**DECLARATION OF BRADLEY J.  
HERREMA IN SUPPORT OF  
WATERMASTER'S NOTICE OF MOTION  
AND MOTION FOR COURT TO  
RECEIVE AND FILE THE 2021/2022  
ANNUAL REPORT OF THE GROUND-  
LEVEL MONITORING COMMITTEE**

# 2021/22 Annual Report of the Ground-Level Monitoring Committee

Appendix B: Response to GLMC Comments

**Figure 3-9**  
**History of Land Subsidence in Northwest MZ-1**  
 Ground-Level Monitoring Committee  
 2021/22 Annual Report

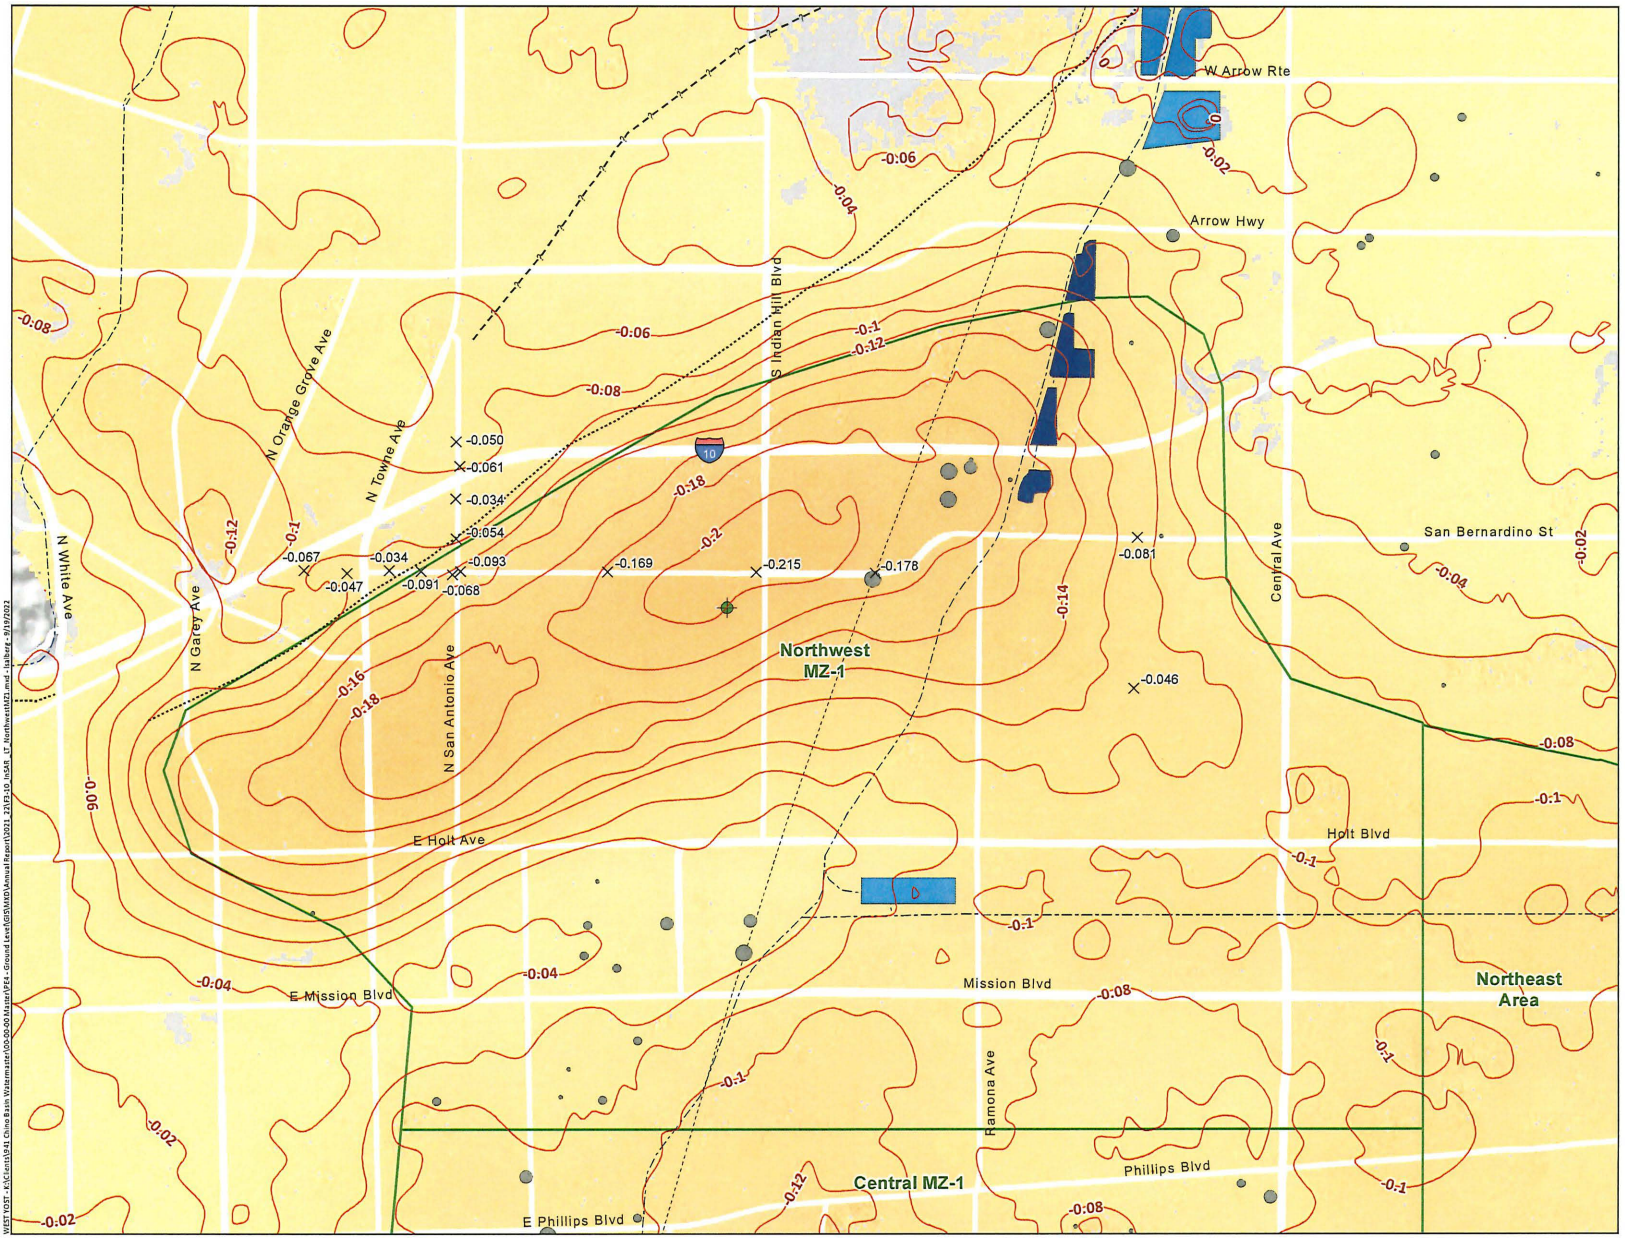
**Comment 3 – Figure 3-9 History of Land Subsidence in Northwest MZ-1**

These suggestions for changes to Figure 3-9 should be discussed and agreed upon by the GLMC.

Figure 3-10

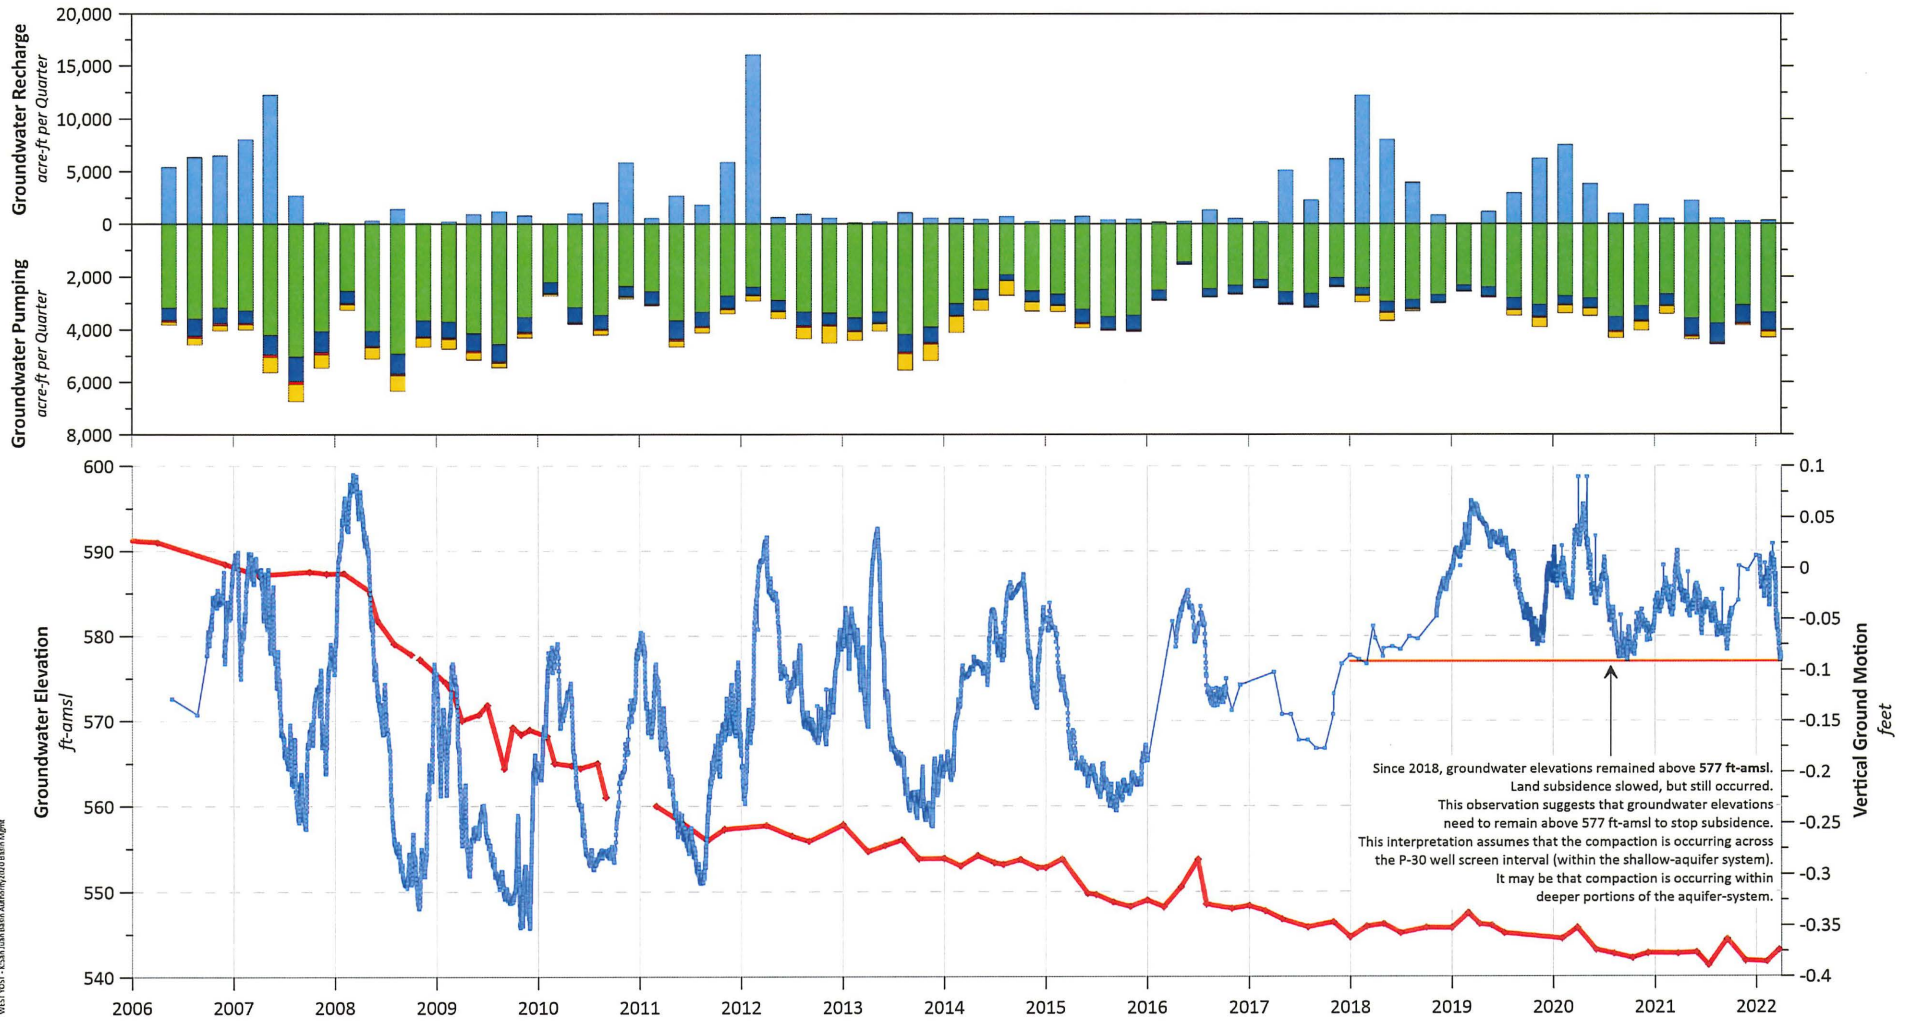
**Comment 4 – Figure 3-10 Vertical Ground Motion across Northwest MZ-1: 2014-2022**

The wells shown on Figure 3-9 are also plotted on the inset map included on Figure 3-9. The purpose of Figure 3-10 is to show a comparison of InSAR data with leveling survey data.

**Hydraulic Heads at P-30 Versus Groundwater Pumping and Vertical Ground Motion**

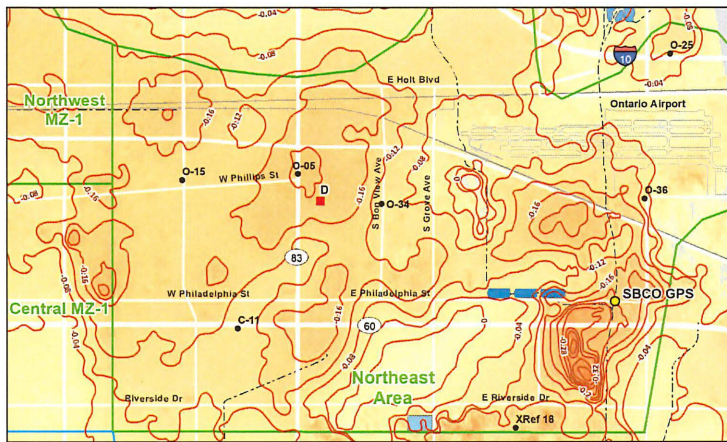
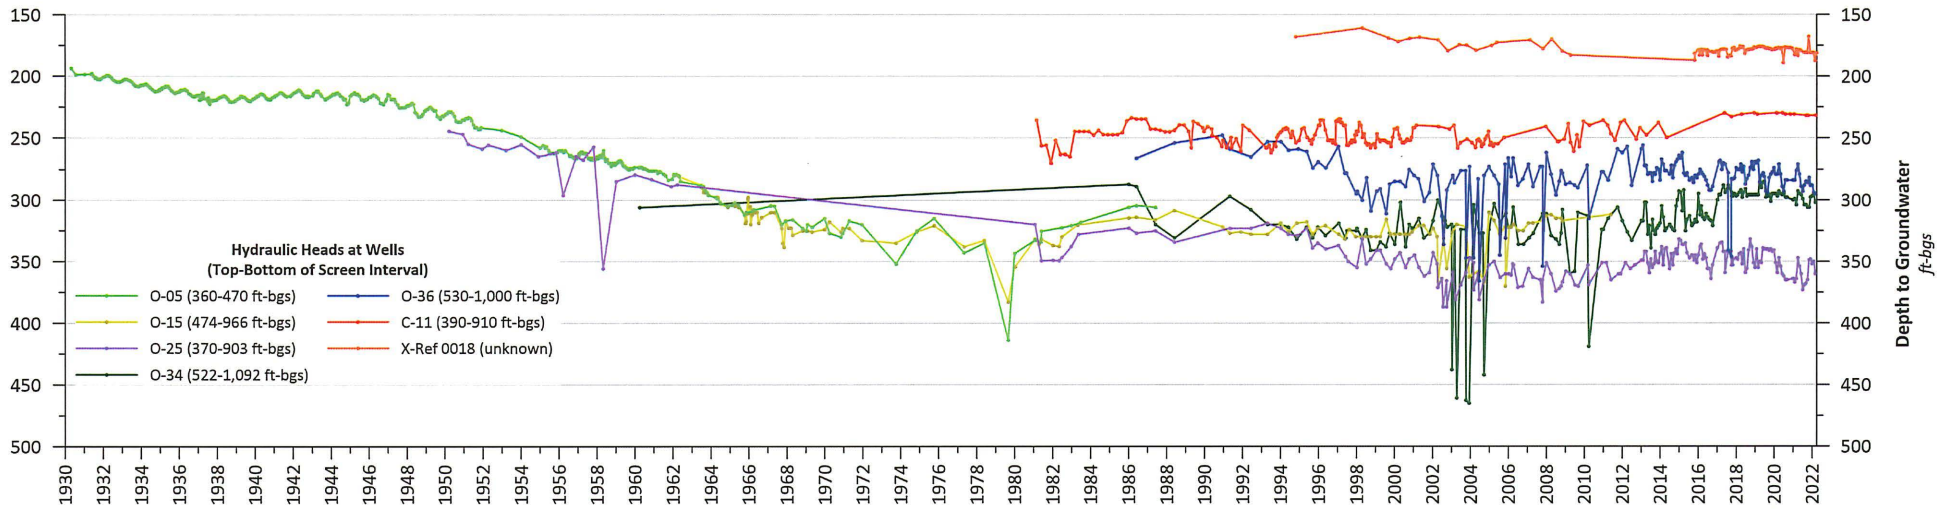
**Comment 5 – Figure 3-11 Hydraulic Heads at P-30 versus Groundwater Pumping and Vertical Ground Motion**

The note on Figure 3-11 describes the limitations of this analysis and the derived interpretations (Figure 3-11 note):
